Somerville High School

SHS School Building Committee Meeting

December 12, 2016

Value Management Opportunities

VE-080:

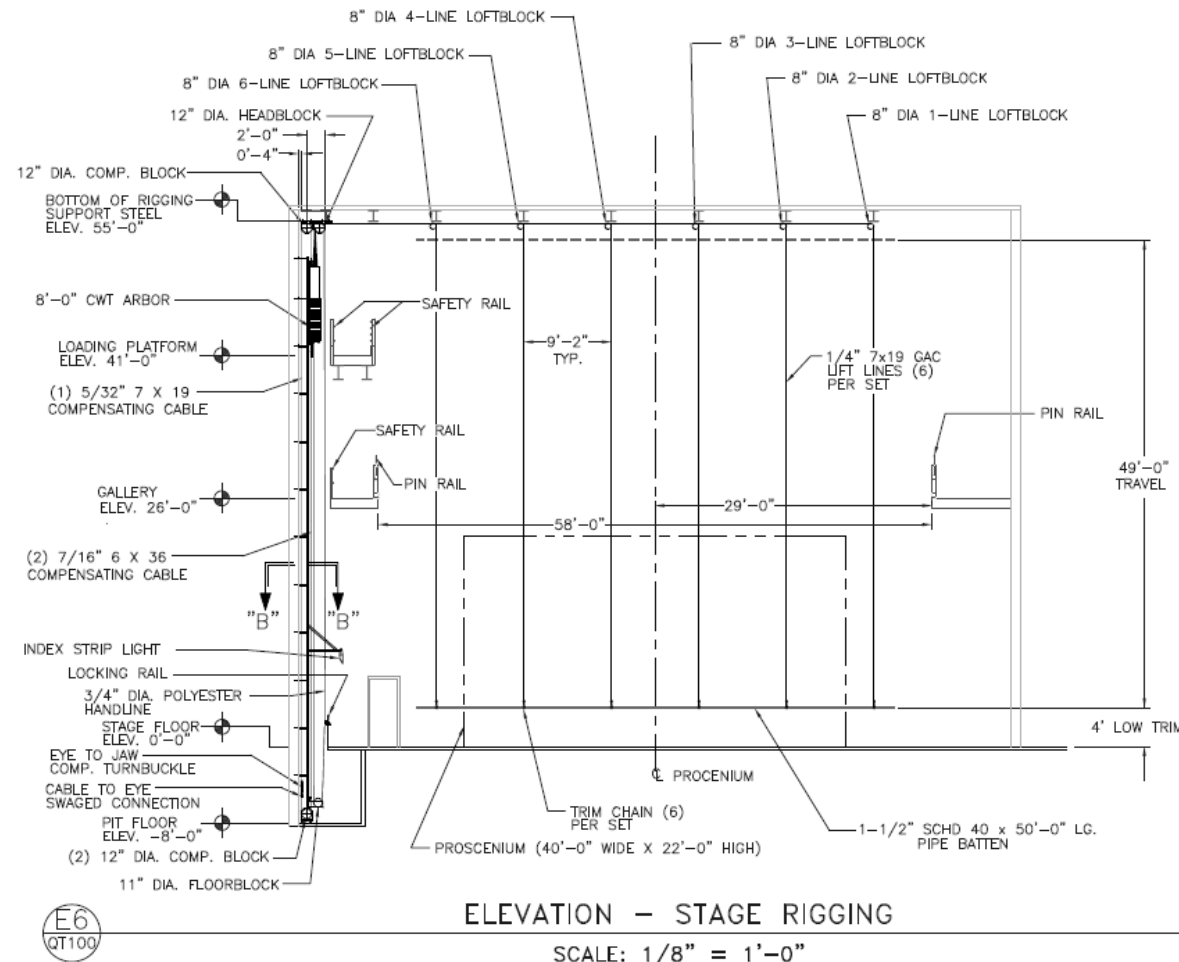
Change from automated rigging system to manual rigging system for the Auditorium stage and adjust pricing for theatrical performance lighting

VE-081:

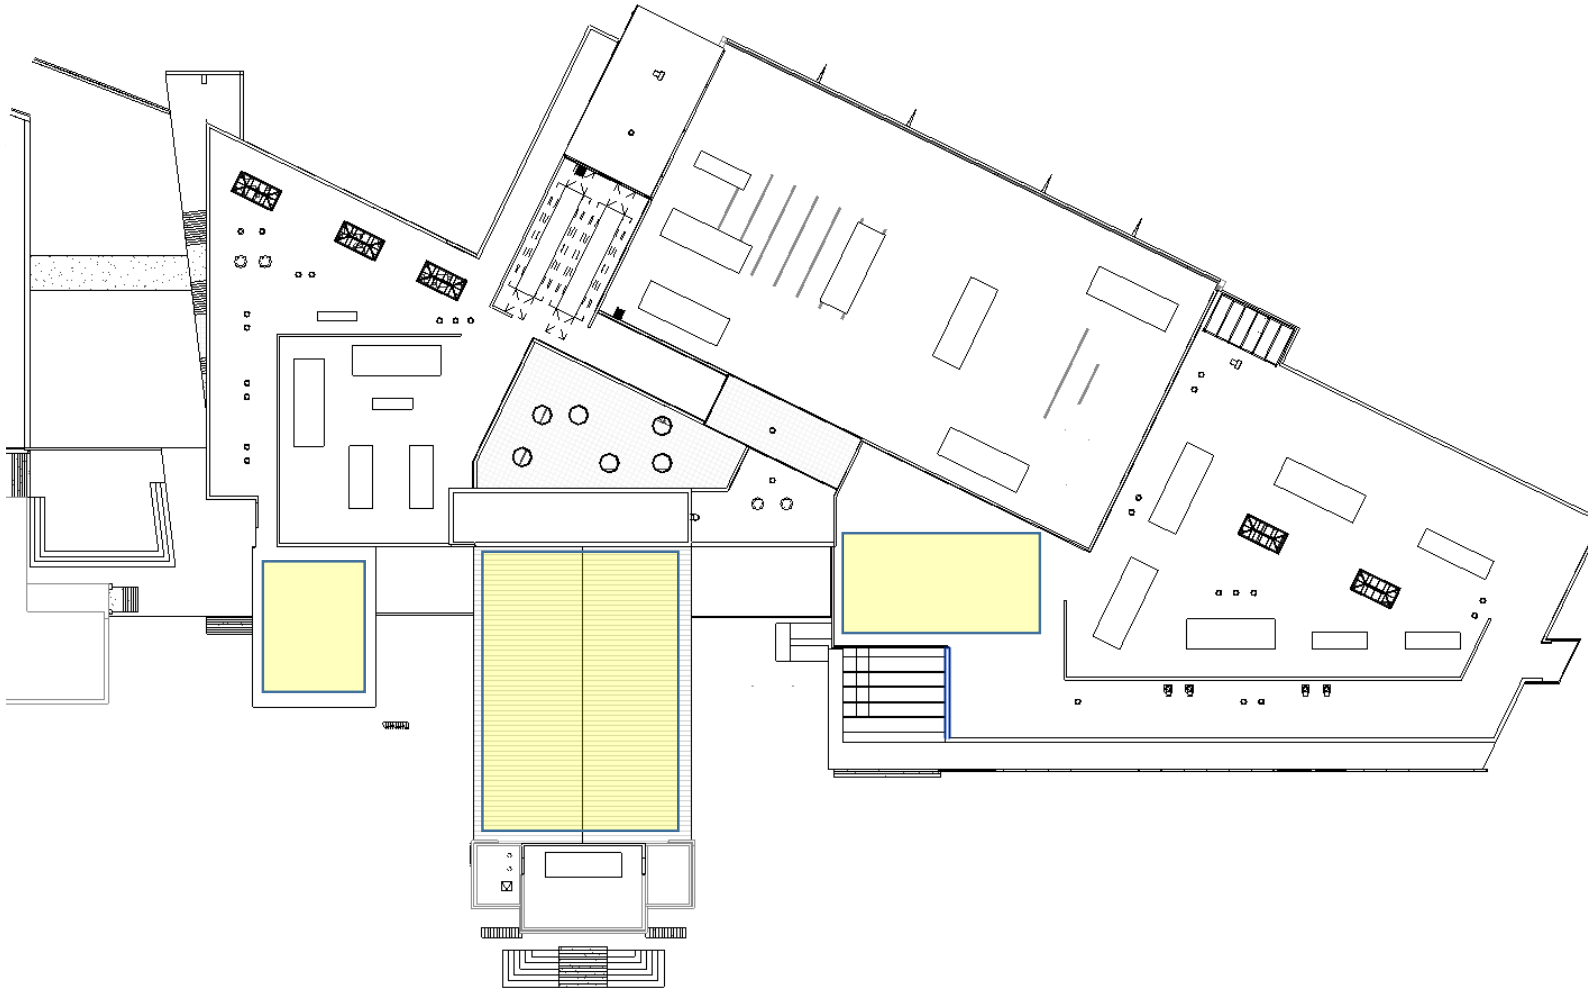
Eliminate additional structural support for future solar provisions

VE-082:

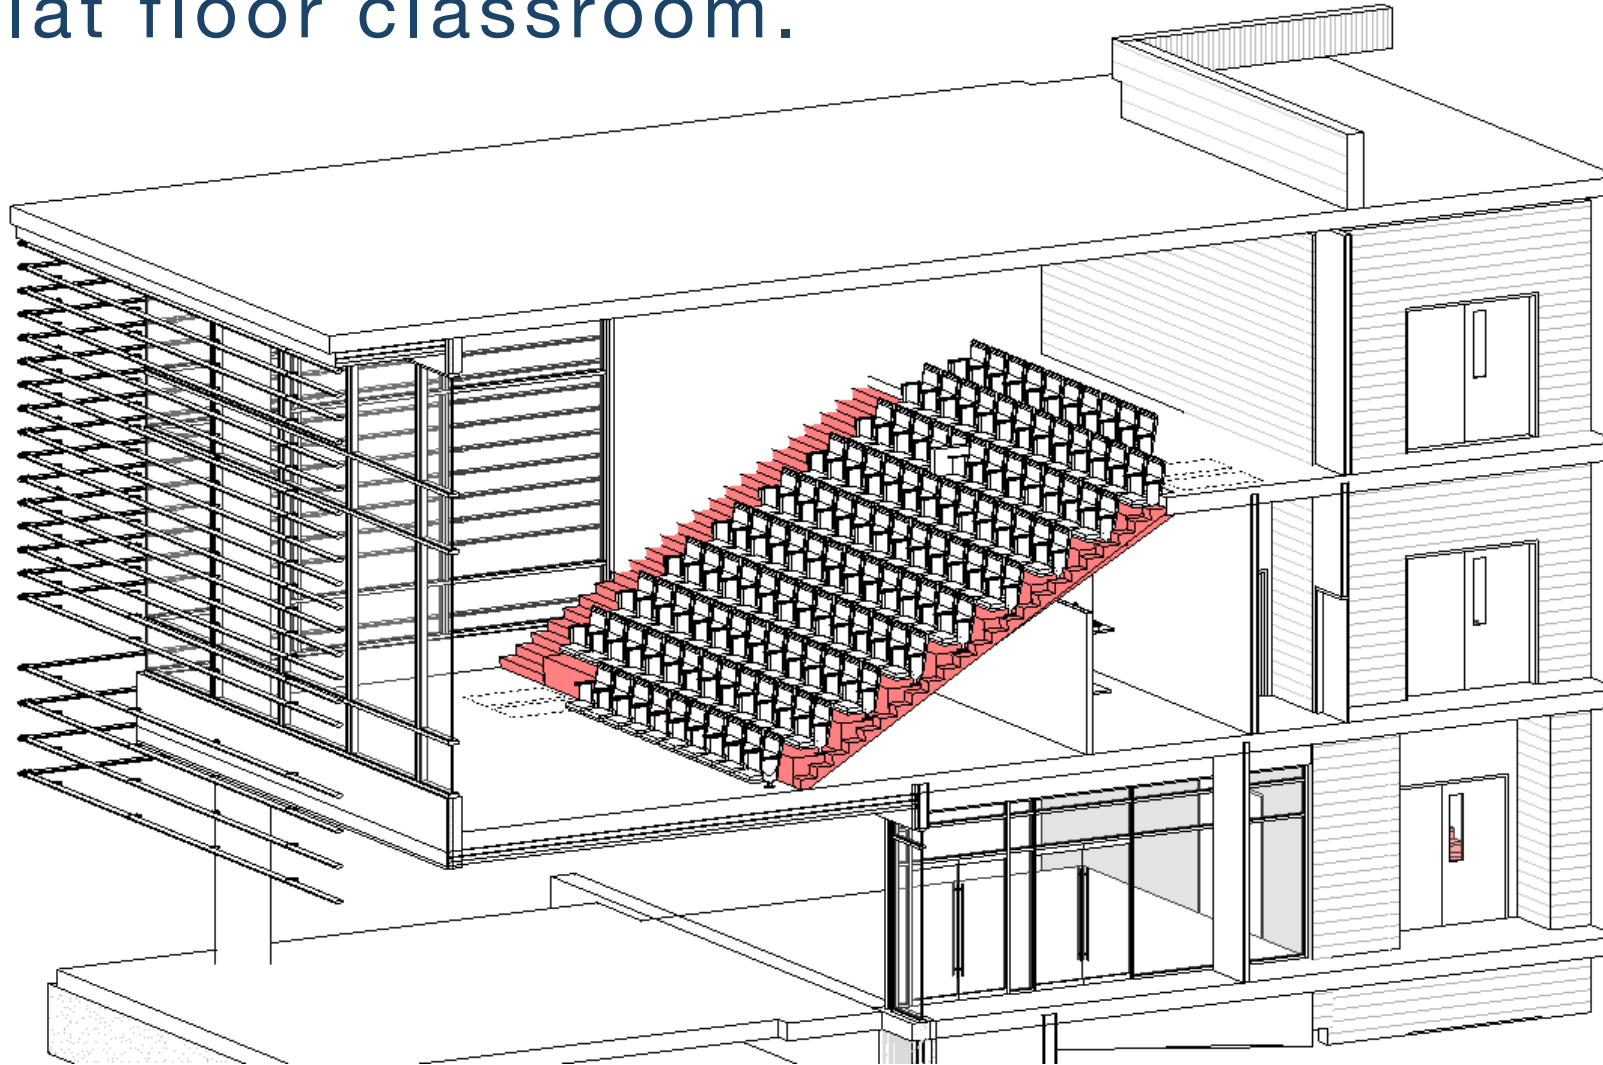
Eliminate sloped seating at Mini Theater, leaving this a flat floor classroom.
